United States Nuclear Regulatory Commission Official Hearing Exhibit	
In the Matter of: DETROIT EDISON COMPANY (Fermi Nuclear Power Plant, Unit 3)	
	ASLBP #: 09-880-05-COL-BD01
	Docket #: 05200033
	Exhibit #: DTE000007-00-BD01
	Admitted: 10/30/2013
	Rejected:
Other:	
	Identified: 10/30/2013
	Withdrawn:
	Stricken:

**Attachment 2
NRC3-09-0017**

Response to RAI letter related to Fermi 3 ER

RAI Question GE3.1-1

Figure 2.1-3 Fermi Property Boundary

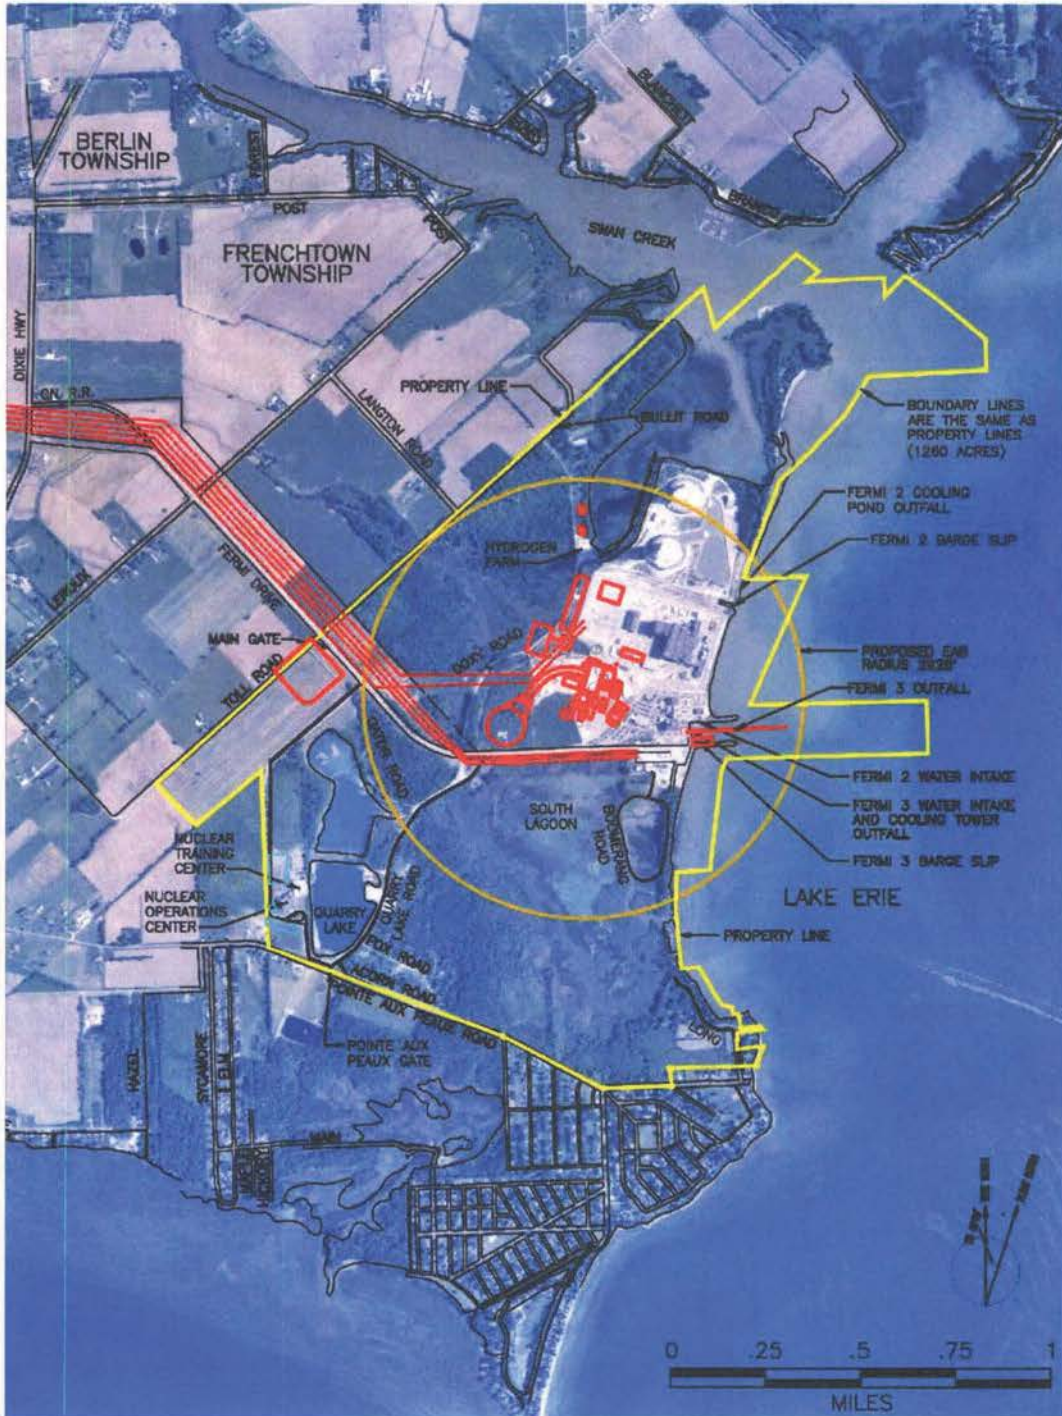
Provide updated site layout information and a complete evaluation and assessment of short-term and long-term direct, indirect, and cumulative impacts on all resources based on site layout changes.

Environmental Report Section	Description of Change
Figures 2.1-3 and 2.1-4	Figures are updated to reflect the updated site layout.
Section 2.2	Updated text based on location of the new meteorological tower and switchyard.
Section 2.5.3	Updated text based on additional archeological surveys performed for the location of the new meteorological tower.
Section 3.1	Figure 3.1-1 is updated to reflect the revised site layout. Figures 3.1-2, 3.1-4, and 3.1-6 are updated to reflect the new location for the Fermi 3 NDCT. Figures 3.1-3, 3.1-5, and 3.1-7 do not require updating as the new location of the NDCT is adequately depicted based on the viewpoint. Section 3.1.2 (page 3-3) is changed to indicate that, based on the new location for the Fermi 3 switchyard, the transmission towers are shared as the lines leave the site. Currently, the statement is that the lines are shared as they leave the facility. With the switchyard moving to the western side of the property, substituting "site" for "facility" is appropriate.
